October 16, 2024

CITY OF COCONUT CREEK
4800 West Copans Road
Coconut Creek, FL 33063
Attn: Liz Aguiar

Project Name: MainStreet Block 8
Project Number: PZ-24040001
Location: NW40th Street and Banks Road
Applicant/Agent: HSQ Group
Review/Application: PMDD Site Plan

We have reviewed the Comments request dated October 5, 2024, and our responses are as follows:

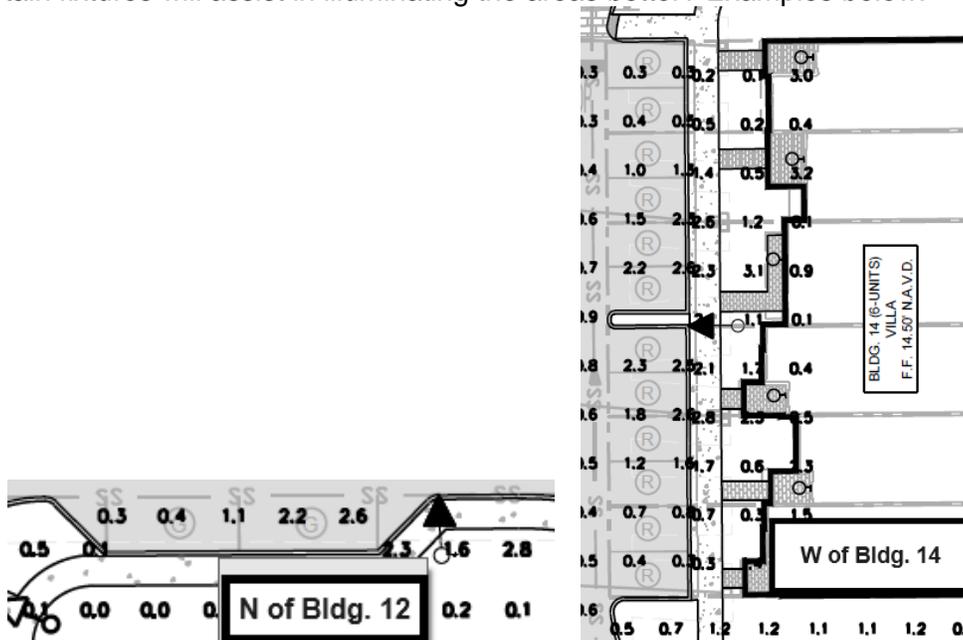
RESPONSE: the project is designed to meet/exceed the minimum parking requirements that are dictated for this type of units, which are based on ite and uli parking rates. This provides a minimum of 2 spaces per unit, plus 10% of the required parking spaces as guest parking. Further, it is not feasible to modify the parallel stalls to perpendicular due to the landscaping and drive aisle width requirements as follows:

- Parallel spaces south of bldg. 12 & 13 must remain as shown. No room to change to perpendicular – sidewalk would be only 1.5' from end unit (need min. 5' for required hedges plus room for trees).
- Parallel spaces west of bldg. 17 & 23 must remain as shown. No room to change to perpendicular because rear alley is not wide enough for perp. Parking (currently 22' need 24')
- Parallel spaces east of bldg. 22 & 28 must remain as shown. No room to change to perpendicular because rear alley is not wide enough for perp. Parking (currently 22' need 24')

Parallel spaces east of bldg. 16 must remain as shown. No room to change to perpendicular because rear alley is not wide enough for perp. Parking (currently 22' need 24').

- Recommend that roadway parking areas meet the IES security lighting guideline for multi-family residence parking lots of an average of 3.0 fc with an average to minimum uniformity ratio of 4:1.
- o There appears to be a pattern of attempting to use one fixture to illuminate numerous parking spaces throughout the property. This causes a discrepancy in uniformity and inadequate fc readings for security lighting in numerous parking areas. Perhaps adding a fixture to certain areas, or moving certain fixtures will assist in illuminating the areas better? Examples below.

RESPONSE: the photometrics and lighting are designed to meet the city code. Additional lights in the front yards of the villa buildings would adversely impact the required trees
